# STAFF REPORT

**RE: 918 Fort Street (Fort St Parking Lot) (permit application #6812)**

## MEMORANDUM

RE: Fort Street Parking Lot, Tree Removal Permit and Landscaping

**PLANTING PLAN**

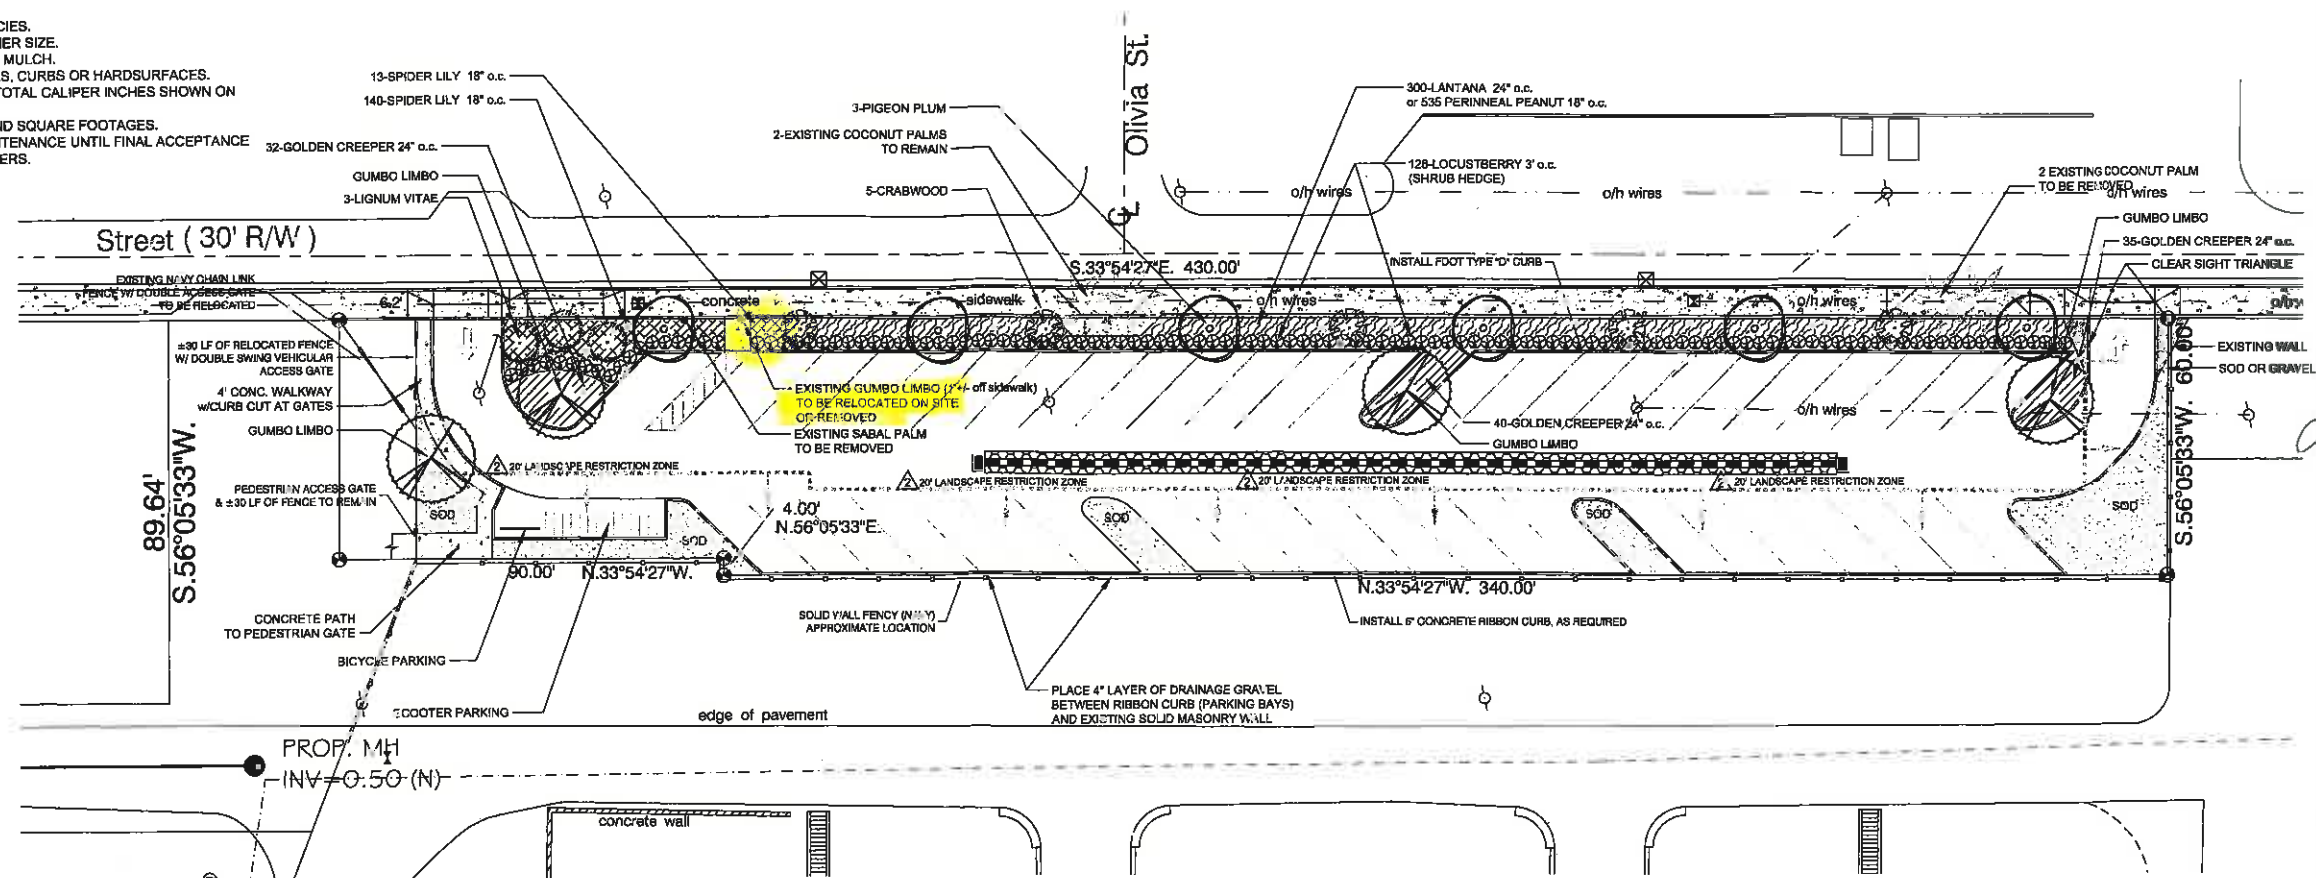
An application was received for the removal of **(1) Gumbo Limbo tree**. A site inspection was done on March 17, 2014 and documented the following:

Location: 40% (under utility lines, will impact sidewalk soon, root system already 12 ft wide)

Condition: 50% (fair to poor-codominat trunks with included bark, old damage from white fly)

**Recommendations: Recommend approval of the removal of (1) Gumbo Limbo tree located at 918 Fort Street (Fort Street Parking lot), to be replaced with 10 caliper inches of FL#1 native dicot trees onsite.**

**SHEET NUMBER:**  
L-1

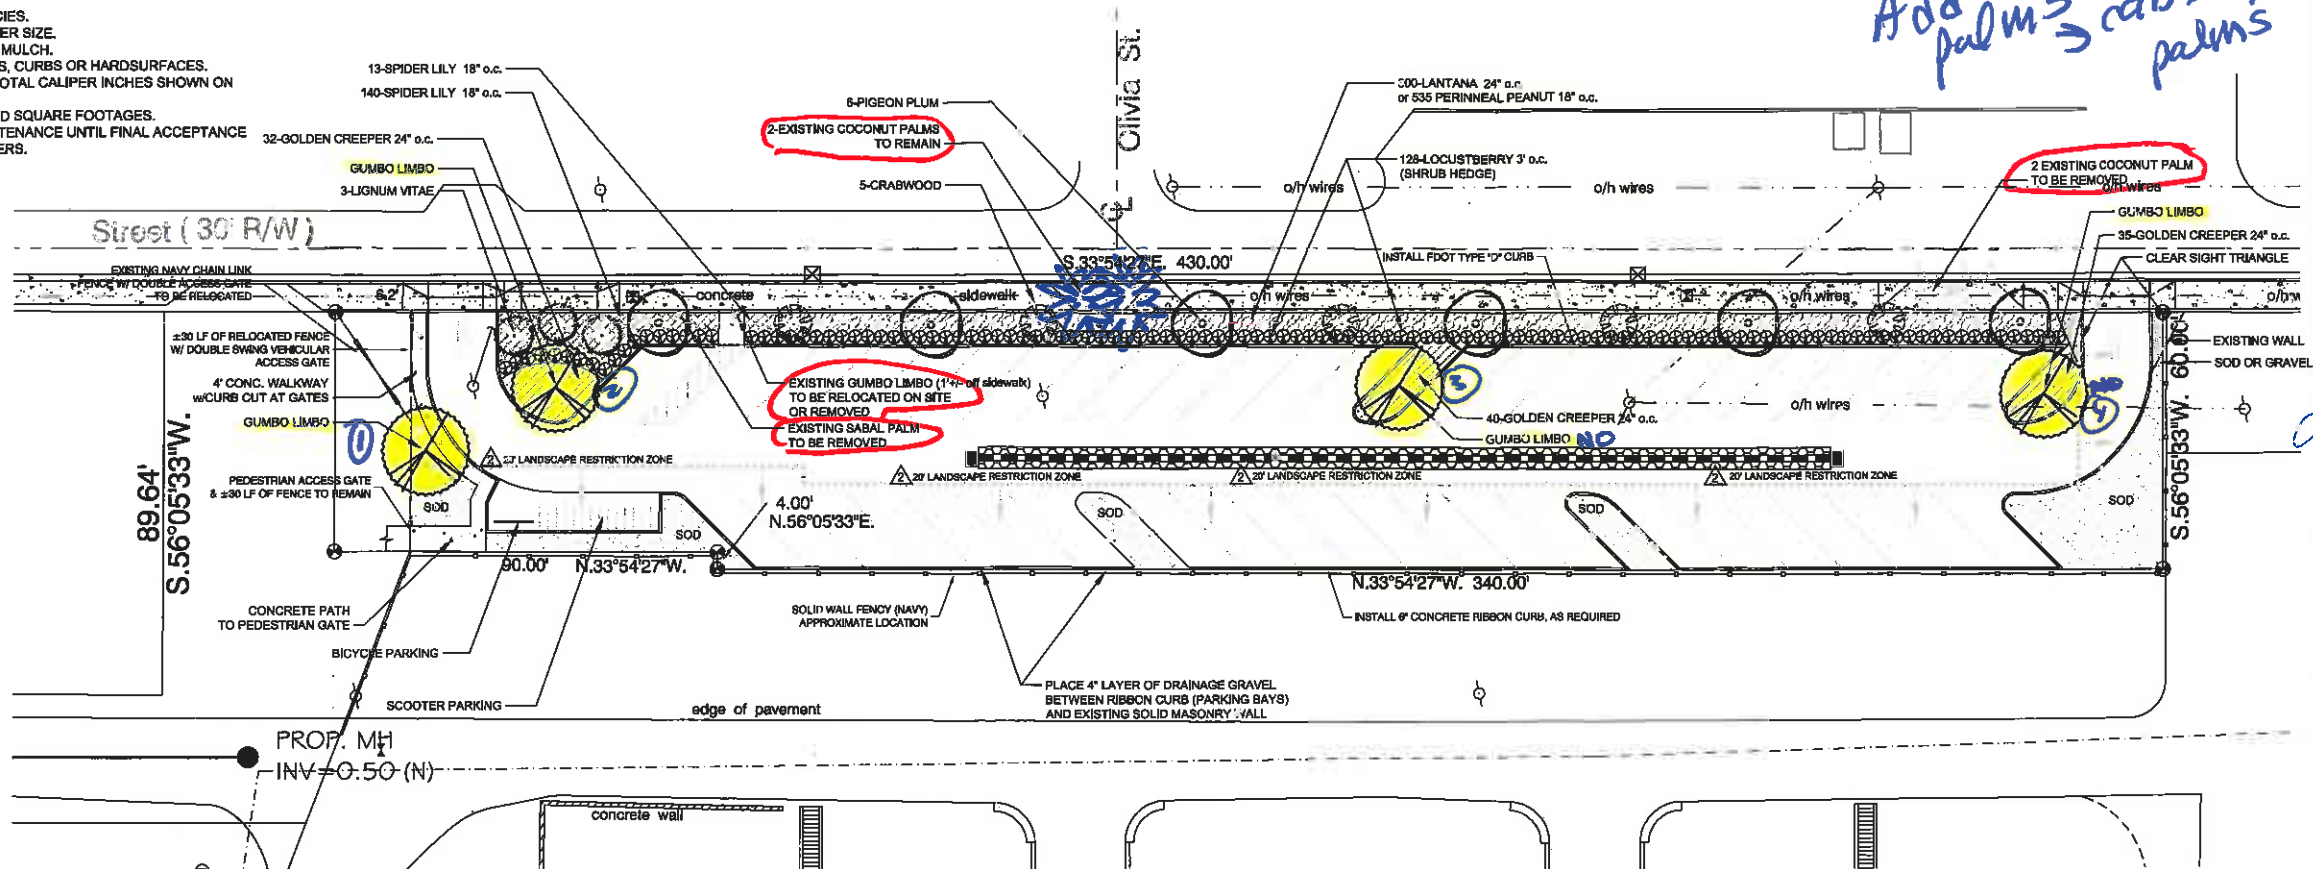
4. **Landscape Plan:** The landscaping to be placed on-site must include the replacements required for the Tree Commission permits (two native palms and 10 caliper inches of FL#1 dicot trees). Reviewing the landscape plan, it appears that 10 caliper inches of native trees has been included but the plan is missing palm trees. Trees on the existing landscape plan recommended for planting include 6-pigeon plum, 3-lignum vitae, and 5-crabwood. Due to security issues, no shrubs will be planted. Groundcover to be planted includes golden creeper and spider lily.

Also, it is recommended that the Gumbo Limbo trees (locations 1-4 on plan) be removed from the landscape plan as they are a canopy tree with large root areas that are not suitable for small street type planters. Therefore, it is recommended that planter locations for gumbo limbos 2-4 be replaced with 3-Sabal palms (to be transplanted from United St/Glynn Archer City Hall) and the existing sabal palm on-site be transplanted to Gumbo limbo location #1.
